To: Planning Committee **Date:** January 9, 2004
From: Holger Burke **File:** RZ 03-231923
 Acting Manager, Development Applications
Re: **APPLICATION BY GURDEV S. LEHL FOR REZONING AT 7831 BENNETT ROAD FROM SINGLE FAMILY HOUSING DISTRICT, SUBDIVISION AREA E (R1/E) TO COMPREHENSIVE DEVELOPMENT DISTRICT (CD/120)**

Staff Report

SITE PLAN
 SCALE: 1/8" = 1'-0"

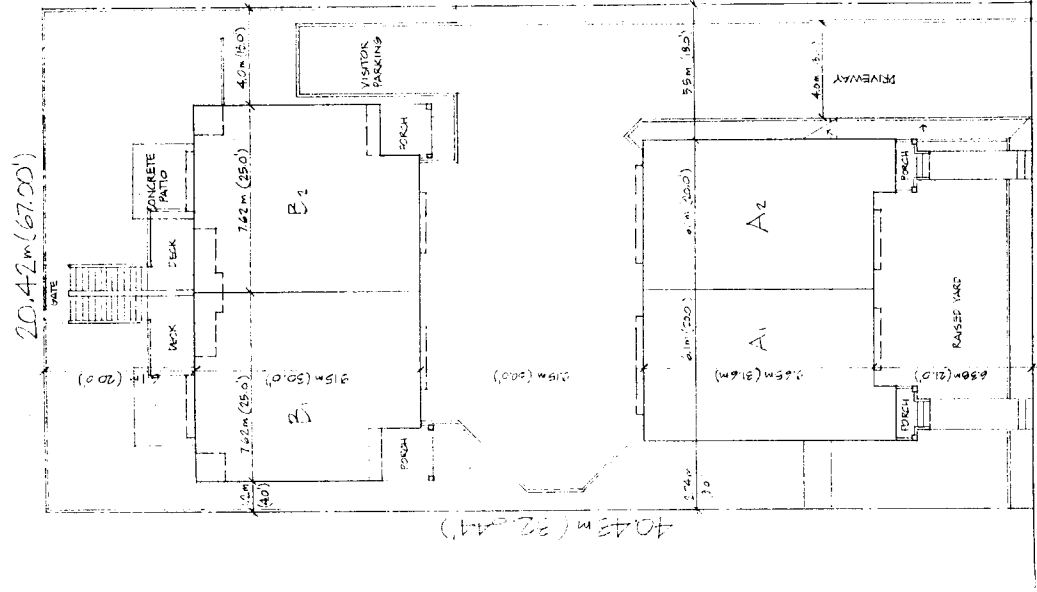
- A landscape architect should be retained to identify the location of the trees and shrubs on the subject property, Brighthouse Park and the Caring Place parking lot that are to be retained, relocated or removed. He/she must also ensure that the proposed new townhouses, decks and stairs are not located within the drip line of any significant trees on the City-owned lands.

- It is recommended that the driveway off Bennett Road also provide access to 7851 Bennett Road should it redevelop. This driveway should have a 4 m (13.1 ft.) driving surface adjacent to the eastern property line and fence so that if the adjacent property redevelops the driveway could be easily widened, with the fence removed, and a walkway would be provided to Brighthouse Park.

- The fence along Brighthouse Park, at the north property line, should be removed and replaced with a lower fence in order to enhance the park openness.

- The porches and front doors of the “B” units at the back of the site must be visible from Bennett Road. A pedestrian path should be provided to the “B1” unit along the western property line to Bennett Road.

- Relocate or delete the visitor parking space and replace with a landscaped pathway to provide access to Brighthouse Park from the site. Relaxation of the required visitor parking space is supported. A gate should be provided in the new fence, for access to the park.
